ADA Curb Ramp New Construction Inspection Form (Perpendicular)

Nw 291 st

23885.56

Nw king ave

PERPENDICULAR RAMP (PR)

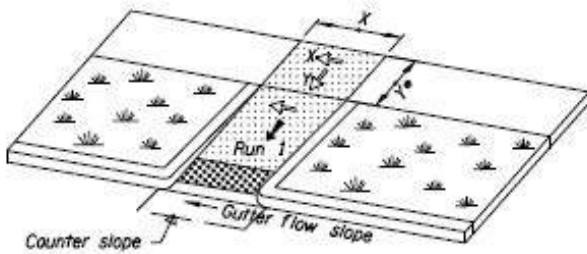
Counter Slope (+/-) *2

5.9

> |5.0%|

RR1 ICRR TS tool joints
